To: Area General Manager
From: Chuck Yaeger - National Customer Service Field Operations Manager
Subject: Special Service Campaign (SSC) 6LD
2004 -2005 Japan Produced RX 330 and Early 2006 RX 400h
Center Console (Floor Carpet Cover) Retaining Clips

TECHNICAL INSTRUCTIONS
FOR
SPECIAL SERVICE CAMPAIGN 6LD
CENTER CONSOLE (FLOOR CARPET COVER)
RETAINING CLIP REPLACEMENT
FOR
2004 THROUGH 2005 MODEL YEAR RX 330 AND
EARLY 2006 MODEL YEAR RX 400h

IV. COMPONENTS

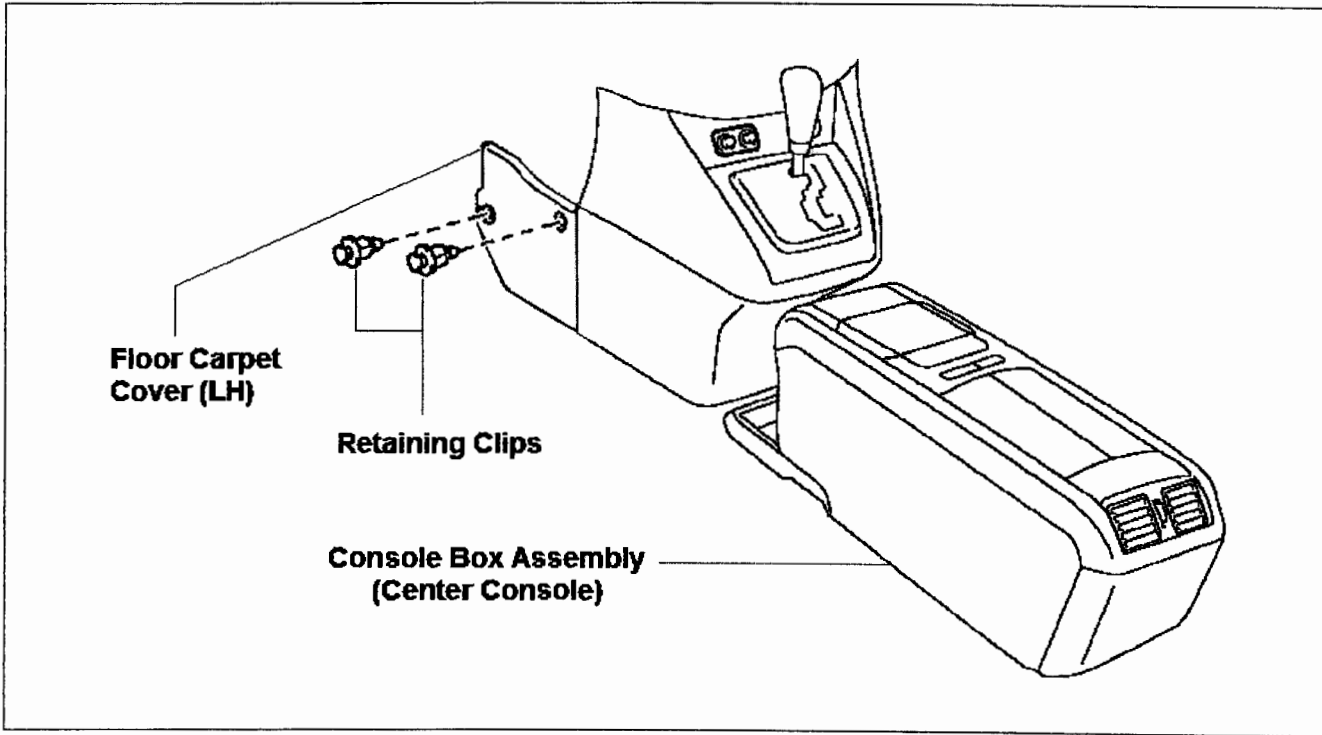
In certain 2004 through 2005 model year Japan produced RX 330 and early 2006 model year RX 400h vehicles, due to improper installation, the two Retaining Clips for the driver's side forward Center Console (Floor Carpet Cover) can become loose. If both clips separate from the Floor Carpet Cover, the cover may lean toward the accelerator pedal, causing interference with the accelerator pedal rod.

1. REMOVE EXISTING CLIPS

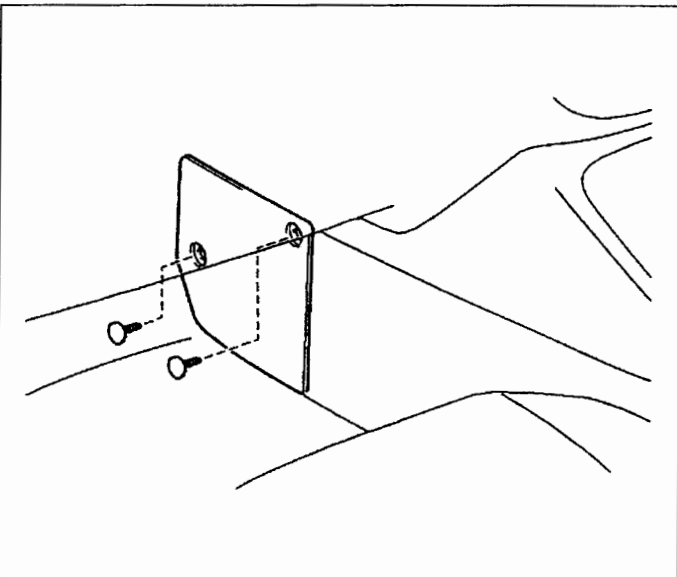
- a) REMOVE, *DESTROY*, AND *DISCARD* THE 2 CLIPS.

- a) INSTALL THE 2 *NEW* CLIPS.
- b) MAKE SURE THE 2 *NEW* CLIPS ARE FASTENED CORRECTLY AND FULLY INSERTED BY PRESSING ON THEM FIRMLY.
